**PROPOSAL TO REISSUE AN EXEMPTION TO AK STEEL CORPORATION FOR  
THE CONTINUED INJECTION OF HAZARDOUS WASTE SUBJECT TO THE LAND  
DISPOSAL RESTRICTIONS OF THE HAZARDOUS AND SOLID WASTE  
AMENDMENTS OF 1984**

**Action:** Notice of Intent to Grant an Exemption for the Injection of Certain Hazardous Wastes to AK Steel Corporation for Two Injection Wells Located at 1801 Crawford Street, Middletown, Ohio.

Figure 1

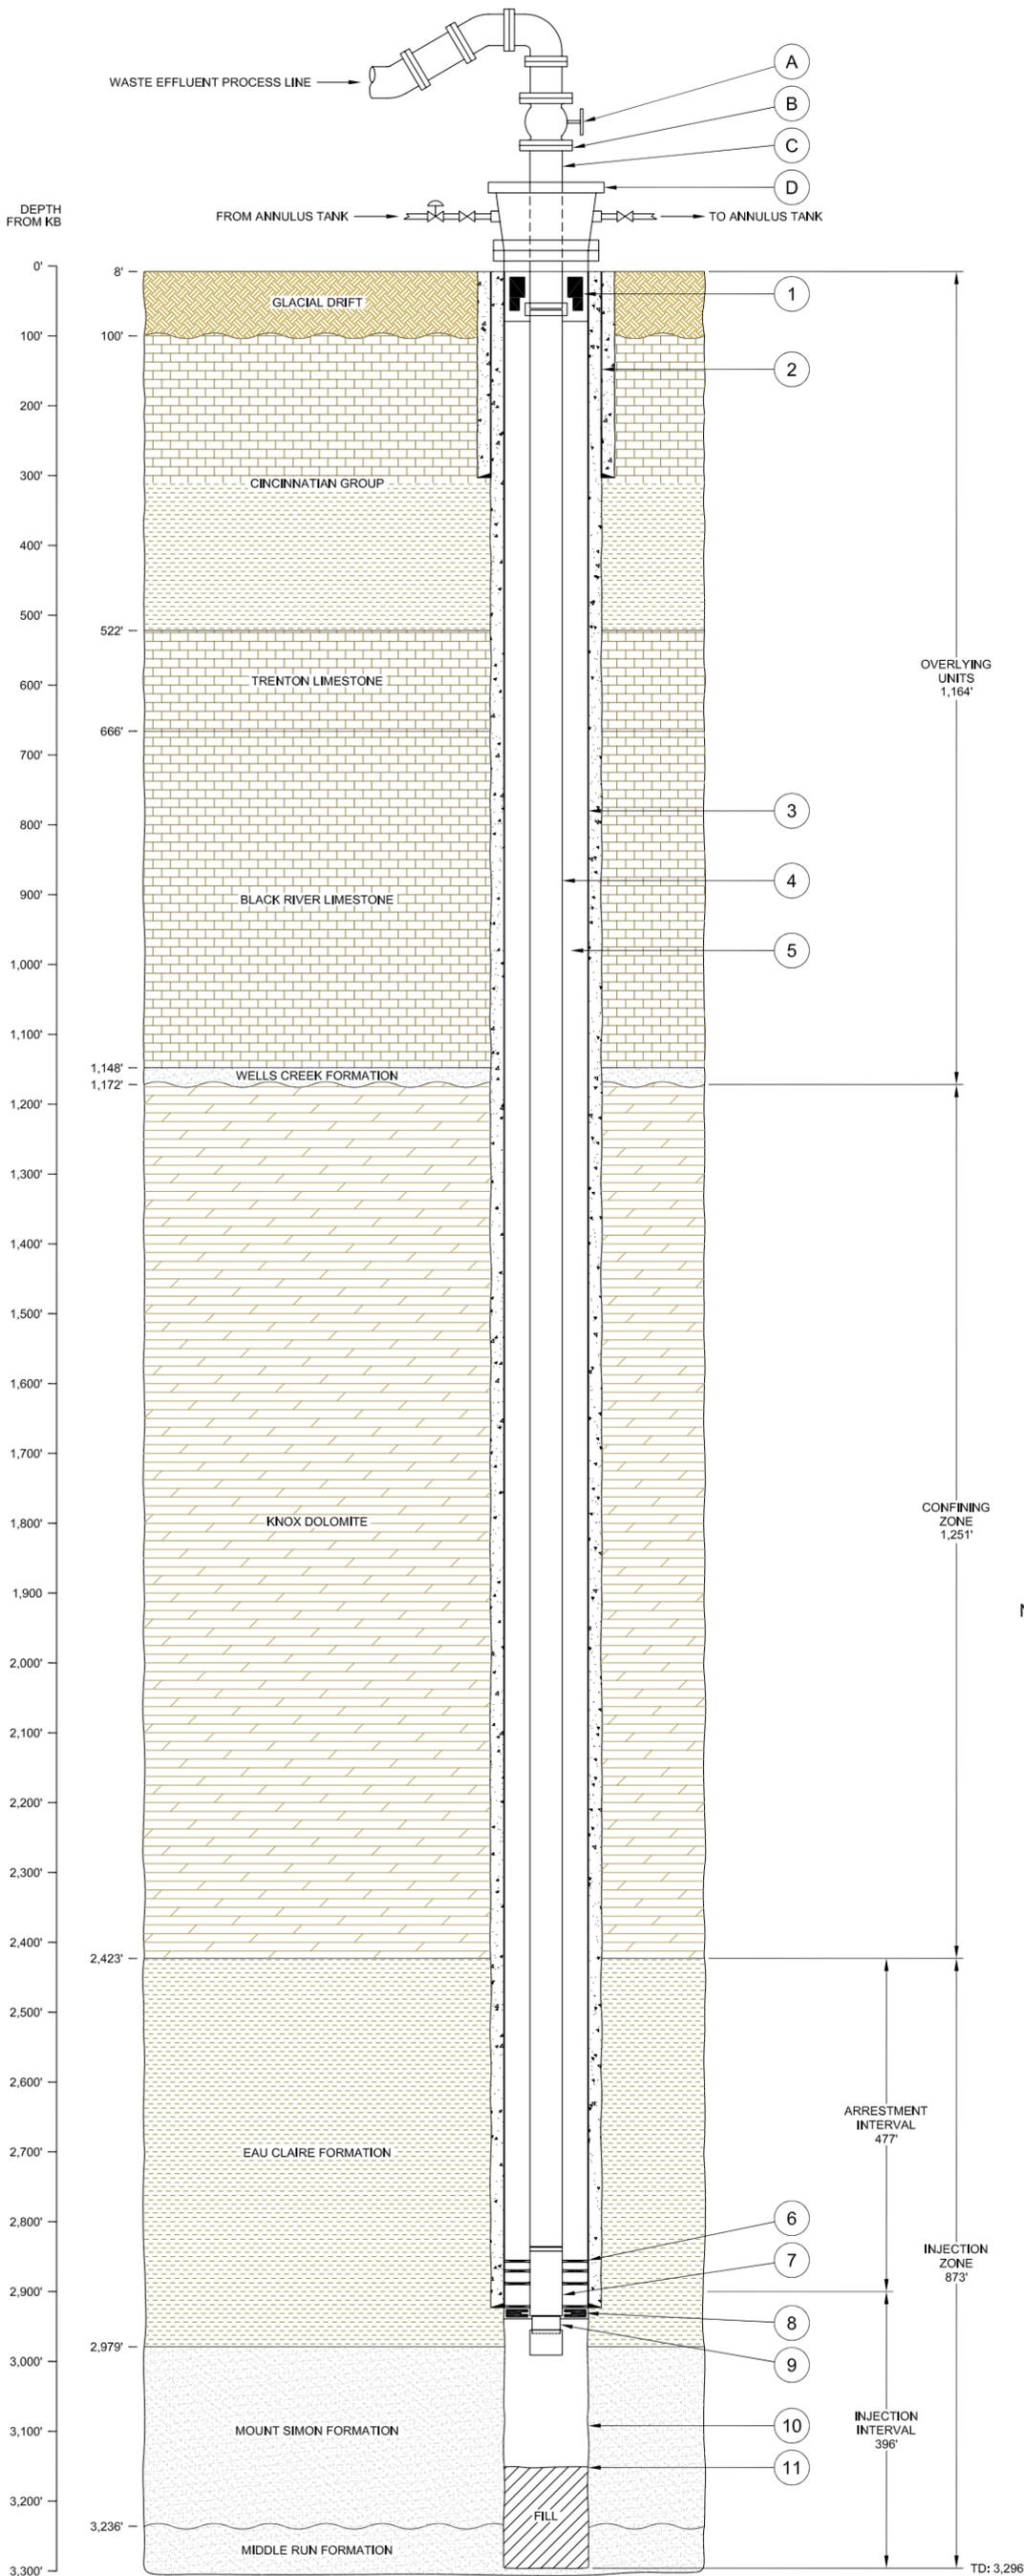
**1. Identification of Underground Sources of Drinking Water** – The lowermost USDW at the site is the Cincinnati Group, less than 522 feet (Figure 1)<sup>1</sup>. There are approximately 1,901 feet of separation between the lowermost USDW and the Injection Interval, where the waste is emplaced. This separation zone is composed of dolomites, shales, sandstones and siltstones which are predominantly characterized by low permeability at this location.

AK Steel used an empirical method to calculate the vertical diffusion distance of hazardous constituents in the post-operational period. A number of conservative assumptions were used to maximize this distance. In the current demonstration, the predicted distance is that at which the concentration of any constituent will be less than one part per million. The greatest distance calculated is 156 feet, much less than the 477-foot thickness of the Arrestment Interval (Figure 1).

Figure 2

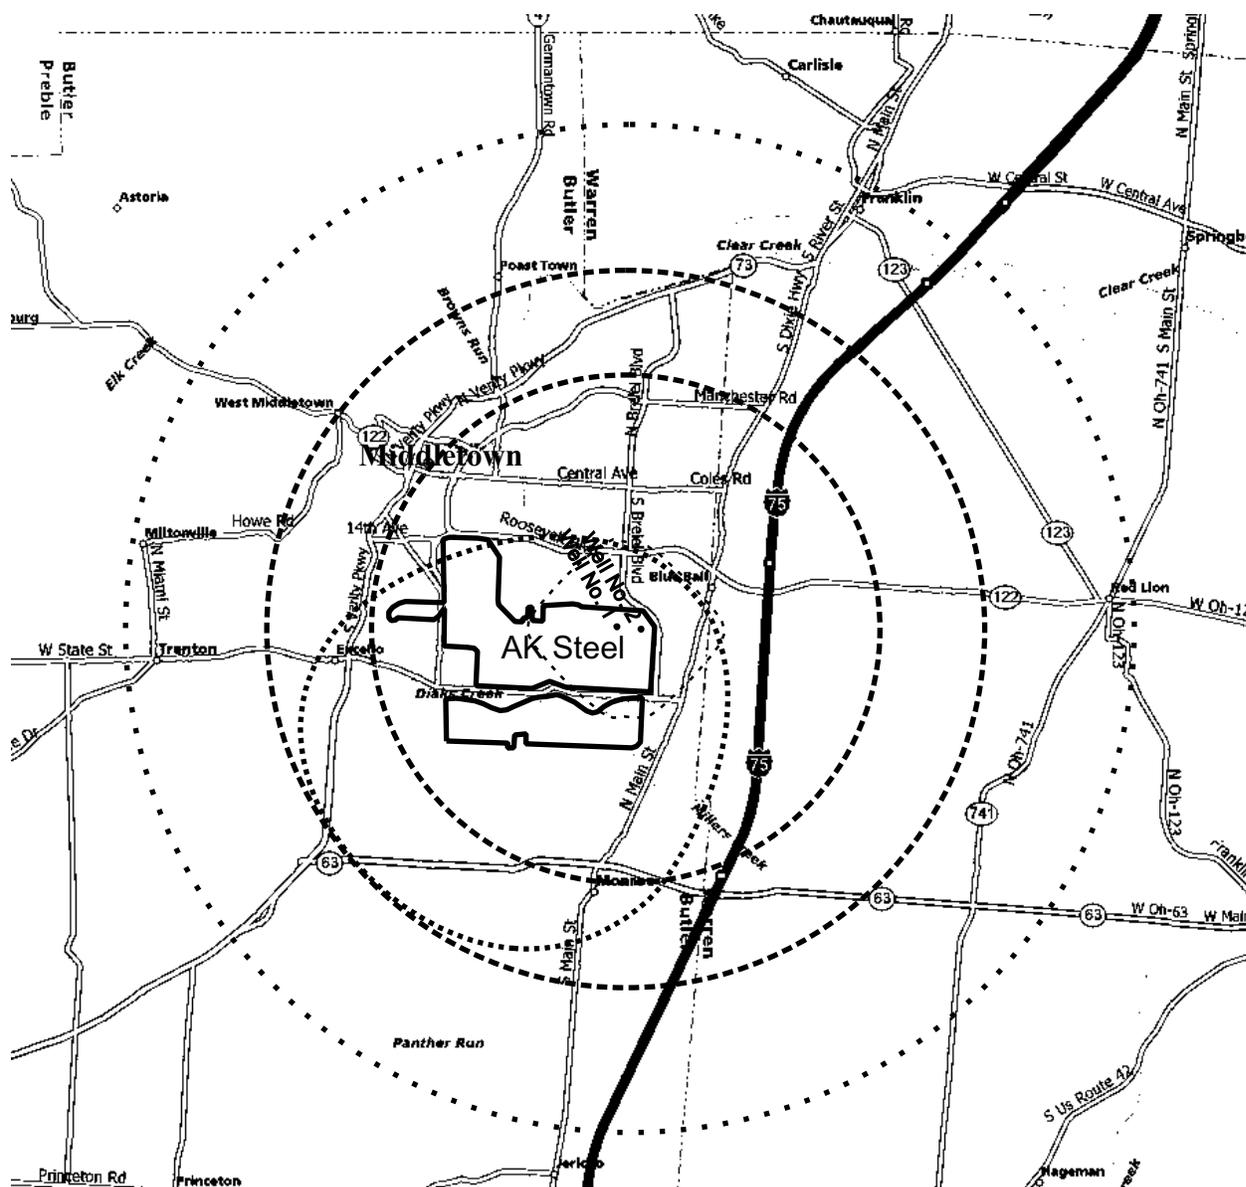
The simulation of plume-flow distance and direction during the 10,000 year post-operational period considered buoyancy and the natural flow within the lower Eau Claire Formation, Mt. Simon Sandstone, and upper Middle Run Sandstone. Calculations based on the measurements made at AK Steel's wells and several others indicated that the rate of regional flow is less than 0.5 ft/year. To maximize plume movement, the model incorporated regional flow in the same direction as the dip of the rock strata, which is to the southwest. In addition, the simulation does not consider the possibility of chemical and physical processes which in reality are likely to retard movement of hazardous constituents. The final plume boundary is shown in Figure 2, with a maximum distance from the injection wells of 3.55 miles.

The nearest point of discharge into a USDW is hundreds of miles away from the facility. Figure 2 shows the distance beyond which we can be very certain that the waste will not spread through a period of 10,000 years, which is 3.55 miles. Therefore, AK Steel has demonstrated that, to a reasonable degree of certainty, hazardous constituents will not migrate vertically out of the injection zone or laterally to a point of discharge in a 10,000 year period.
